# SERVICE BULLETIN

DATE: 24 MARCH 2021

\* Supersedes Service Bulletins SB369H-263R1, SB369D-229R1, SB369E-129R1, SB369F-119R1, SB500N-066R1, and SB600N-080R1, dated 15 May 2020. Revised to delete compliance Method 2 and to add a reoccurring 300-hour borescope inspection of the pilot-to-copilot tail rotor torque tube.

## INSPECTION OF THE PILOT-TO-COPILOT TAIL ROTOR TORQUE TUBE

**Figure 1. Borescope Inspection of the Torque Tube**

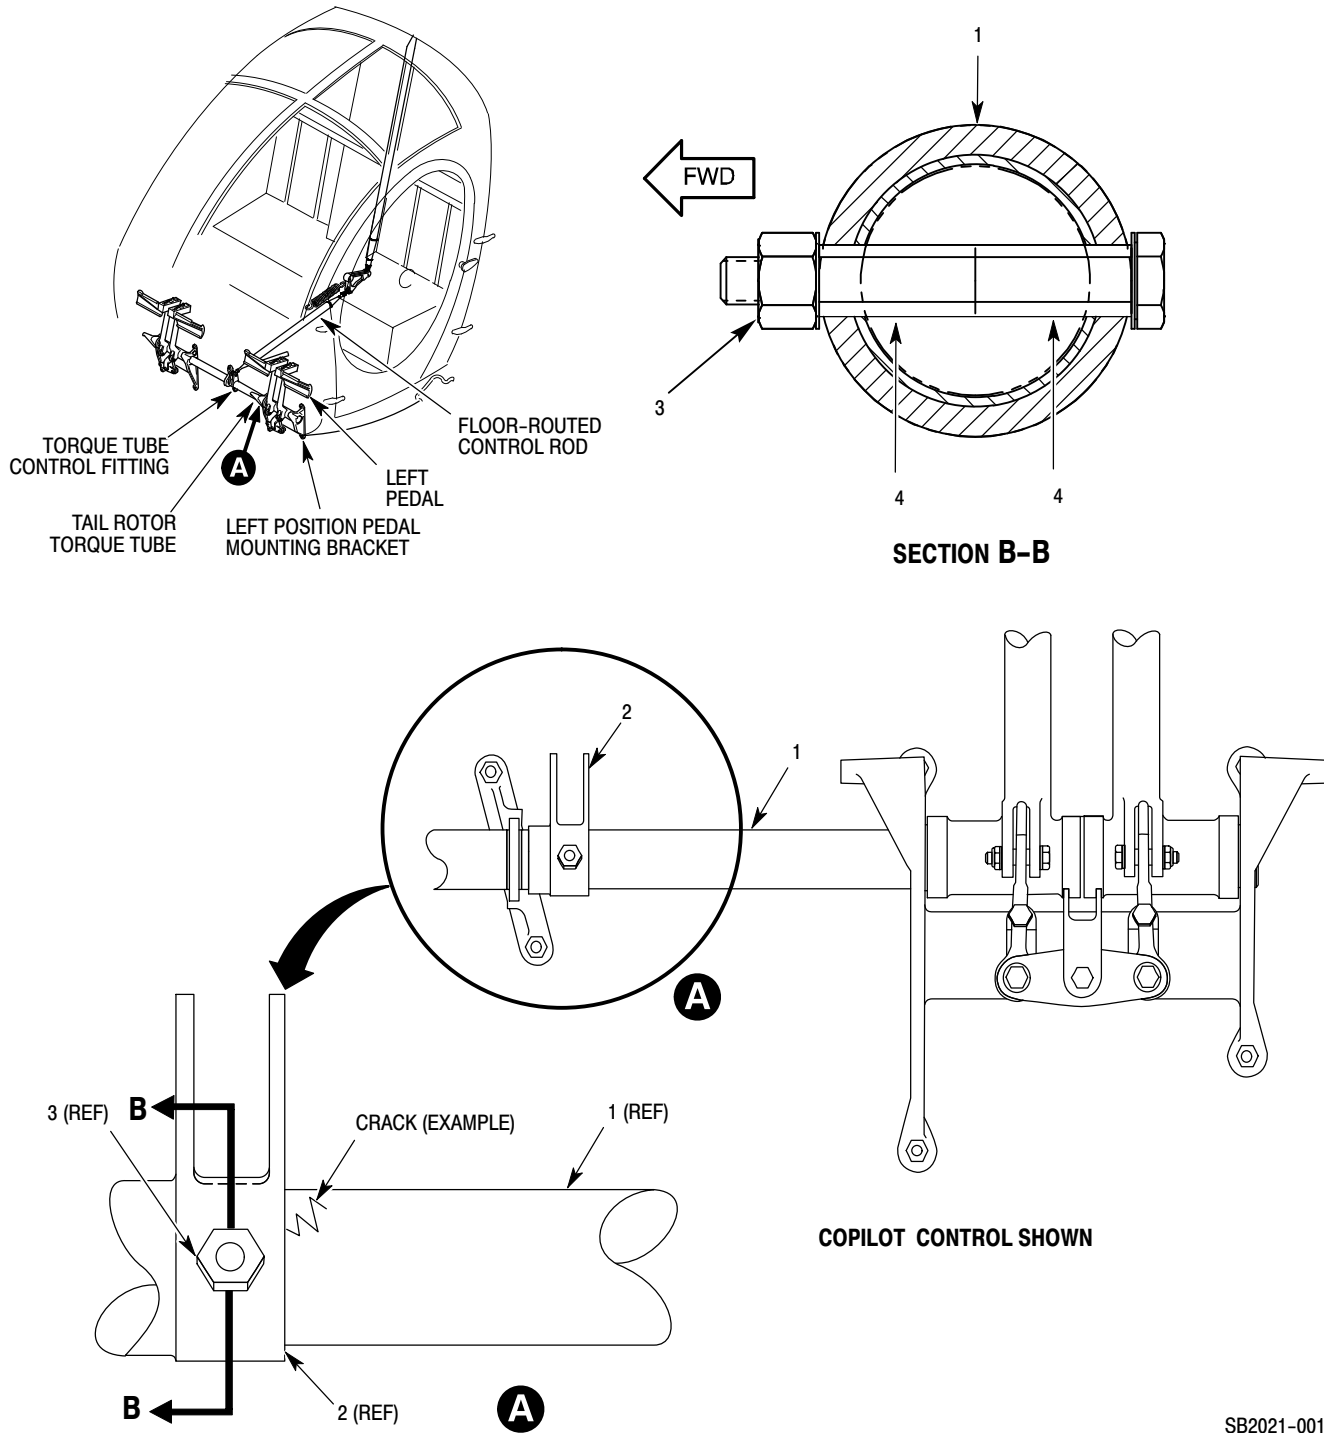
MDHI has received a 369H7531 pilot-to-copilot tail rotor torque tube with a significant spiral crack that seems to have originated from a hole where the tail rotor torque tube control fitting attaches to the torque tube. The crack caused reduced directional control pedal authority.

- (3). Examine the interior of torque tube (1) with a borescope for cracks, elongation, and other damage.
  - (a). Fully examine the area around the interface of torque tube (1) and bushing segments (4).
  - (b). Replace a torque tube with cracks, elongation, or damage. (Ref. CSP-HMI-2, 67-20-10, Removal / Installation, procedures 5. or 6.)
- (4). Examine the tail rotor torque tube interior with a borescope at every 300-hour inspection.

- (1). Get access to the inspection area, as necessary.
- (2). Examine the exterior of torque tube (1) with a bright light and a mirror for cracks, elongation, and other damage.
